STANDING ROCK SIOUX TRIBE

RE: Draft Environmental Assessment for the Campbell County Wind Farm

Campbell County Wind EA (DOE/EA-1955)
Response to Comments

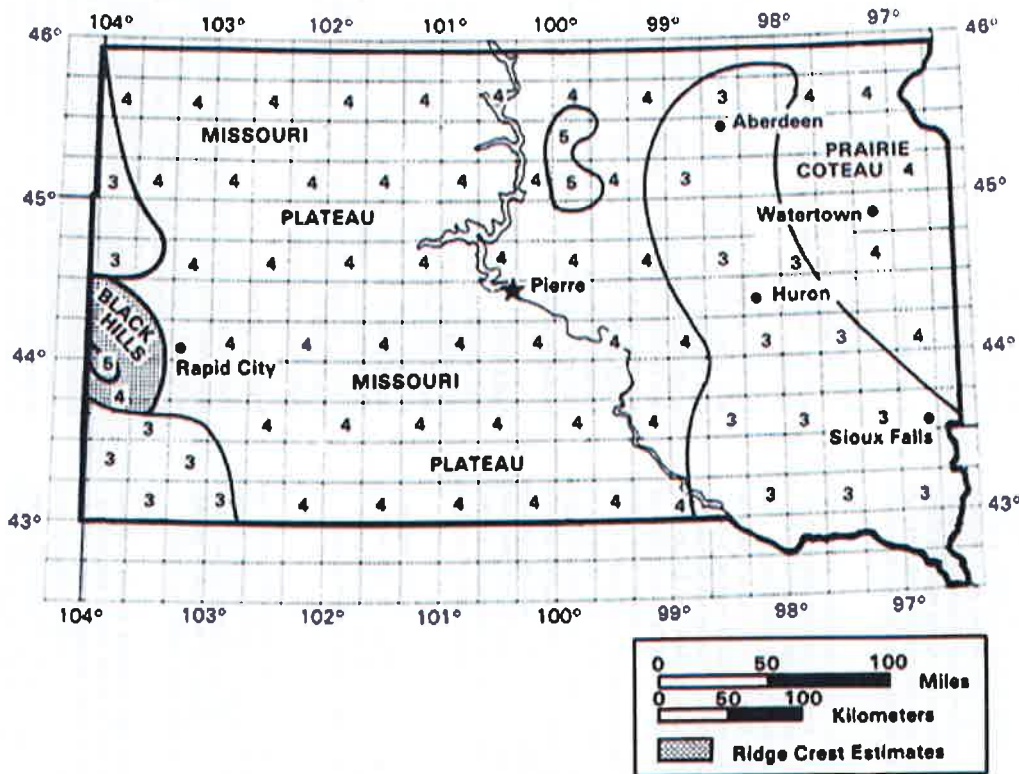
Please provide the documentation that a superior wind regime exists in Campbell County as the following graphic demonstrates that it is on par with almost the entire state of South Dakota. Wind regime of 3 is considered usable for industrial scale wind farms by the way. Each little box on this sheet is approximately 23 miles therefore Campbell County would be within a wind regime of 4 which occurs almost entirely over the entire state. The statement that this location represents a "superior wind regime to provide consumers with strong wind capacity at economic prices" is clearly not factual. There is only one consumer for this energy so marketing it as cost efficient for consumers is a fallacy.

There is absolutely no discussion of why these alternatives were eliminated as their arguments for choosing this location do not hold up to scrutiny. There are numerous locations throughout the state that could host such a wind farm and in areas where it would be on already-tilled land. Additionally, some of the poorest counties in the Nation not just the State occur within South Dakota so the argument of providing economic benefit to an area in need also does hold up under scrutiny due to their being other areas in greater need for an economic benefit that provide the exact same wind regime and contain just as much already tilled land owing in large part to agricultural activities much like Campbell County.

Response to Comment 22
